2.0 SITE CHARACTERISTICS

This section provides details about the site location and site area description for the VEGP site. The proposed ESP Units 3 and 4 would be built on the VEGP site adjacent to existing VEGP Units 1 and 2. The 3169-acre VEGP site is located on a coastal plain bluff southwest of the Savannah River in eastern Burke County. The site exclusion area boundary (EAB) is bounded by River Road, Hancock Landing Road, and 1.7 miles of the Savannah River. The site is approximately 30 river-miles above the U.S. Highway 301 bridge and directly across the river from the U.S. Department of Energy (DOE) Savannah River Site (SRS), in Barnwell County, South Carolina. The VEGP site is approximately 15 miles northeast of Waynesboro, Georgia, and 26 miles southeast of Augusta, Georgia, which is the nearest population center (with more than 25,000 residents).

Following the procedures described in RS-002, Section 2.1.1, the NRC staff reviewed Section 2.1.1 of the SSAR in the VEGP application regarding the site location and site area description, as well as the information the applicant provided in response to the NRC staff's RAI 2.1.1-2 and 2.1.1-3.

Figure 2.4.4-1 - Stage hydrograph at the VEGP Site

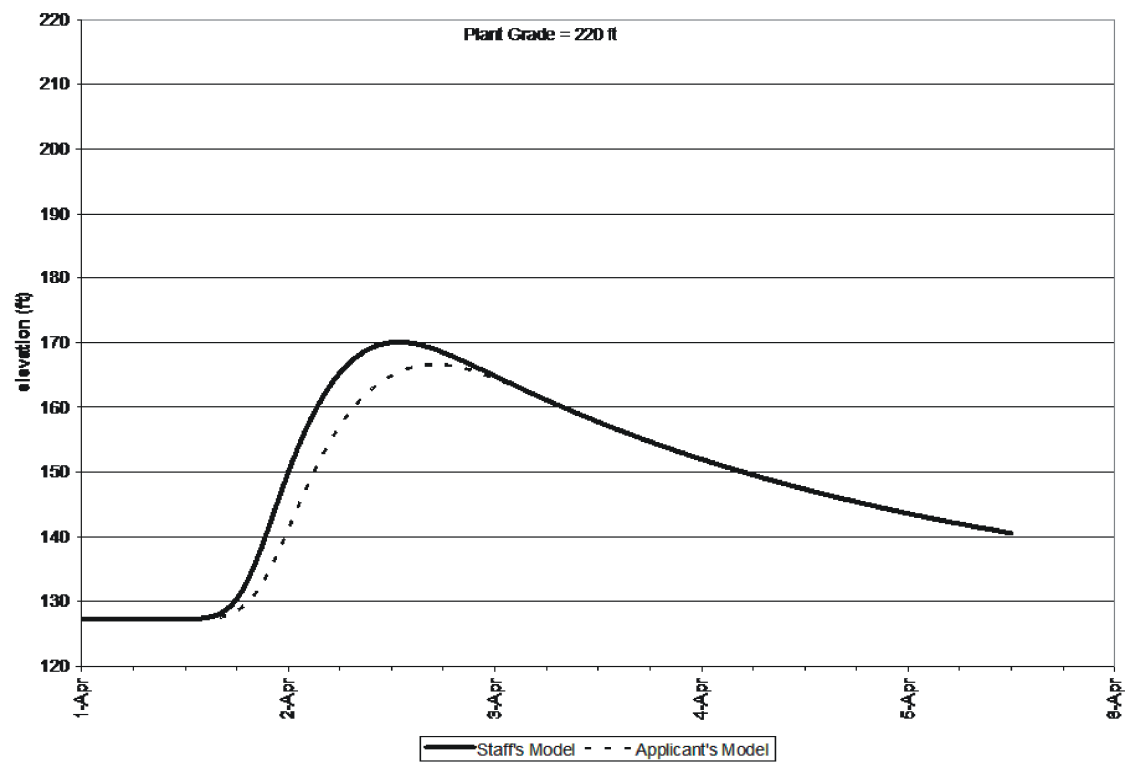
The NRC staff computed the peak discharge at the VEGP site, after it was attenuated along the 70 miles between Thurmond Dam and the site, with approximately 2.5 million cfs. The hydrograph of water surface elevation in the Savannah River near the VEGP site is shown in Figure 2.4.4-1 of the SER. The applicant computed the peak static water surface elevation at the VEGP site as 166.8 feet (Southern 2007). The NRC staff's analysis, with a 50 percent increase in breach area, produced a peak water surface elevation of 170.1 feet at the site, an increase in peak flood stage of 3.3 feet.

Figure 2.4.12-1 Hydrogeologic cross-section of the Water Table aquifer at the Vogtle site (KH is the horizontal hydraulic conductivity)

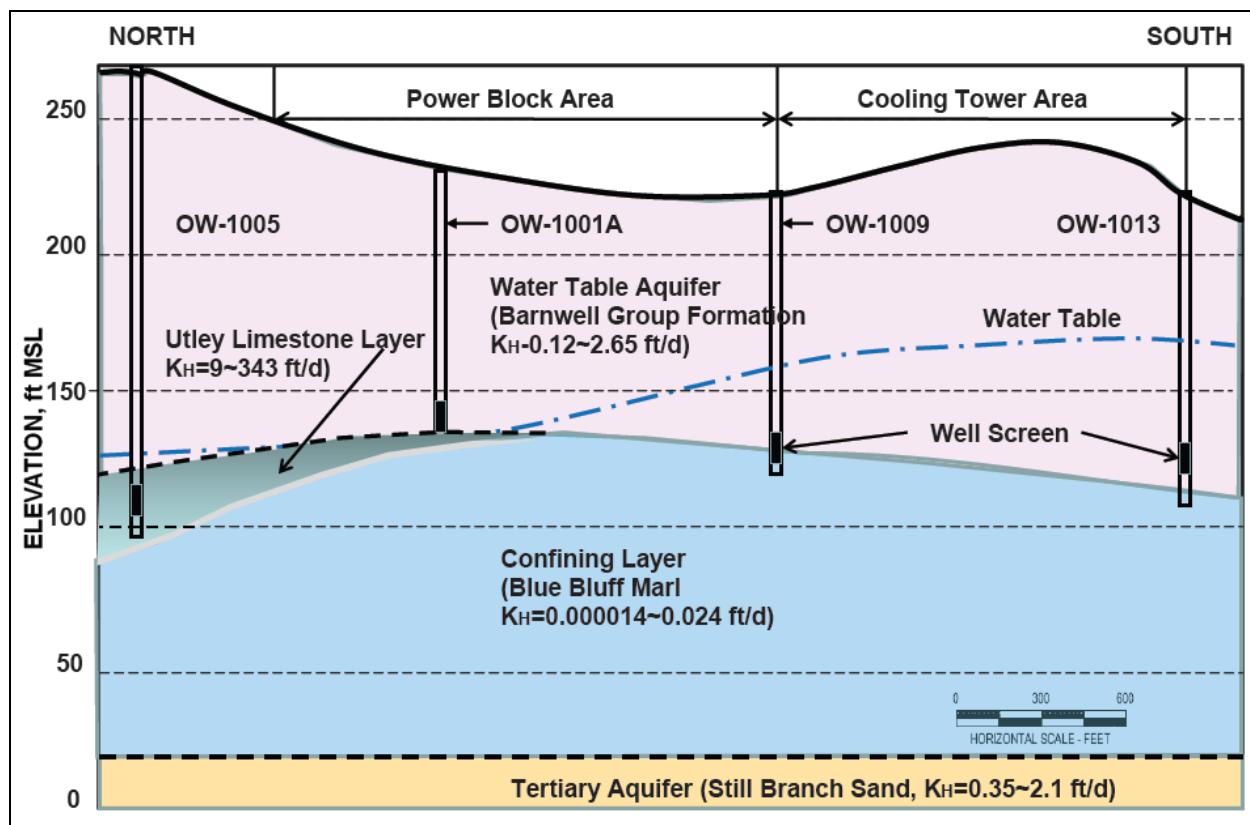
The applicant described the hydrogeology in Section 2.4.12.1.1 of the SSAR (SNC 2008b). The thickness of Coastal Plain sediments varies from less than 200 feet at the fall line to 4000 feet at the coastline, and is approximately 1000 feet thick at the site (SNC 2008b, Section 2.4.12.1.1). A surface topography of gently rolling hills ranges in elevation from 80 feet above MSL to nearly 300 feet above MSL in the immediate vicinity of the VEGP site (SNC 2008a, Part 3, Sections 2.4.1 and 2.6.1). Developed portions of the site have ground surface elevations of approximately 220 feet MSL (SNC 2008b, Section 2.4.12, pg. 2.4.12-1, and Figure 2.4.12-1). The Savannah River has incised the Coastal Plain sediments and formed steep bluffs exhibiting topographic relief of nearly 150 feet from the river to the developed portions of the existing VEGP site (SNC 2008a, Part 3, Section 2.6.1).

Figure 2.4.14-1 - The Proposed facility boundary for the VEGP site
(Taken from SSAR Figure 1-4).

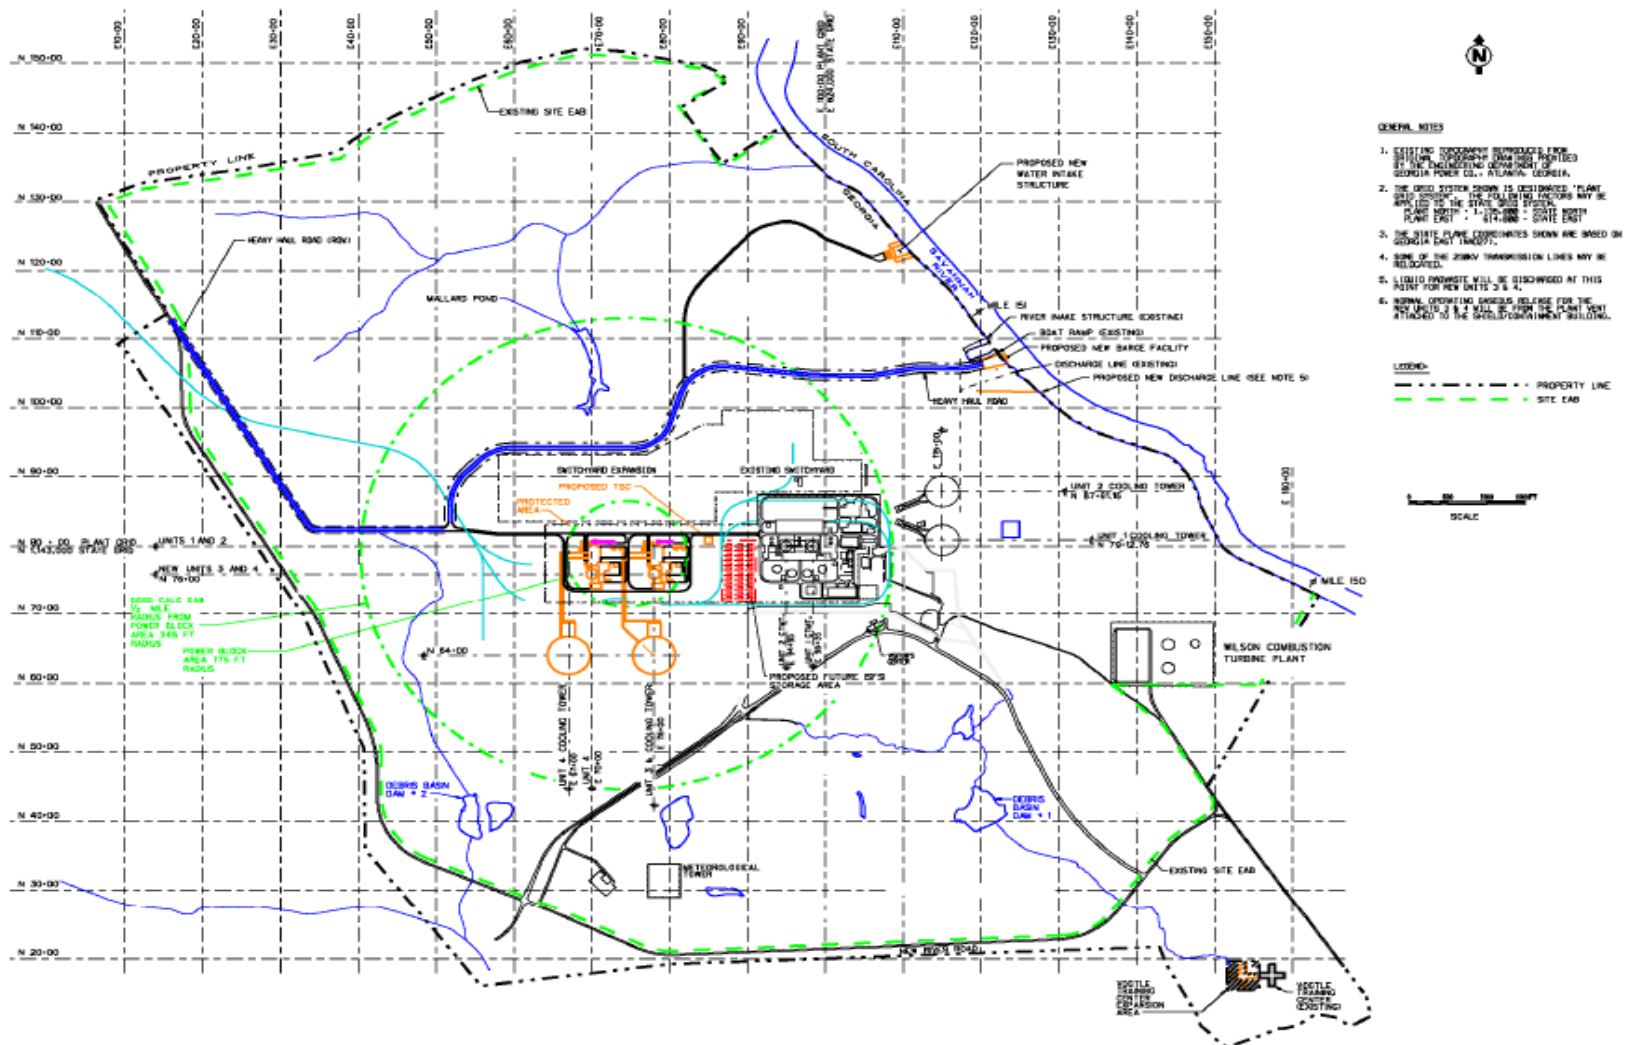
The proposed Units 3 and 4 would be located within the existing VEGP site adjacent to existing Units 1 and 2. The ESP site boundary, as shown in Figure 1-4 of the SSAR, is the same as the

site boundary for the existing VEGP Units 1 and 2. This figure depicts both the existing units and the proposed units in addition to the site boundary, exclusion area boundary (EAB), protected area (PA) for the proposed units, visitor's center, and Plant Wilson, a six-unit oil-fueled combustion turbine facility owned by Georgia Power Company (GPC), which is also located on the VEGP site.

Figure 1-4 of the SSAR depicts the boundary lines of the exclusion area for the proposed ESP site, which is the same as the EAB for the existing VEGP Units 1 and 2. The EAB is bounded by River Road, Hancock Landing Road, and 1.7 miles of the Savannah River. No state or
